RFI 24

Project: COOLEY LABORATORY RENOVATION
Job: 3146 COOLEY LAB, PPA# 10-0023
Customer: STOFMT MSU BOZEMAN

Item: Power Requirements Emergency Shower Type: ELECTRICAL
Reference: E0.1 note W Spec. Section:
Attachments: Cut Sheet Water Saver Emergency Shower

AP280-230
 INDOOR COMBINATION STROBE LIGHT AND ALARM HORN WITH WEATHERPROOF FLOW SWITCH ASSEMBLY

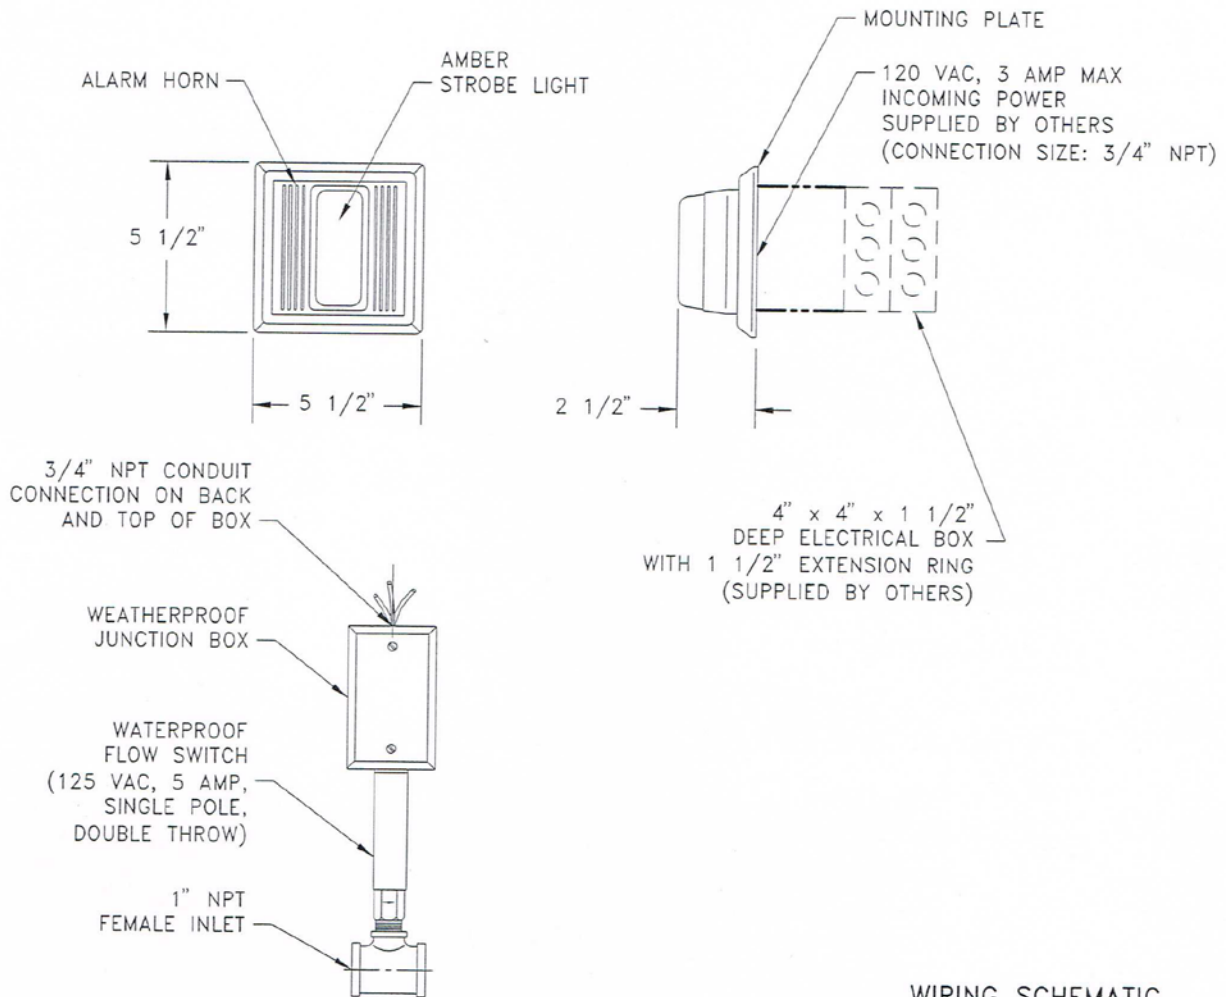
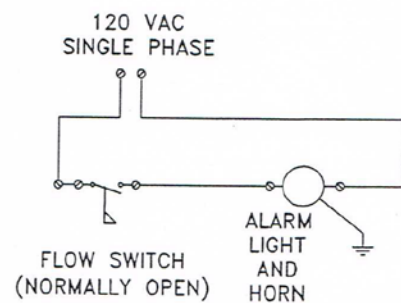
Question:
The emergency shower units require 120 VAC, 3 amp power for operation of the flow switch and and horn/strobe see attached cut sheet. We are not currently seeing this power requirement called for on drawings.

Recommendation:
Provide power to these units. Please let us know what panel this power requirement should come from.

Location and wiring for shower horn/strobes will be shown on an upcoming RFP.
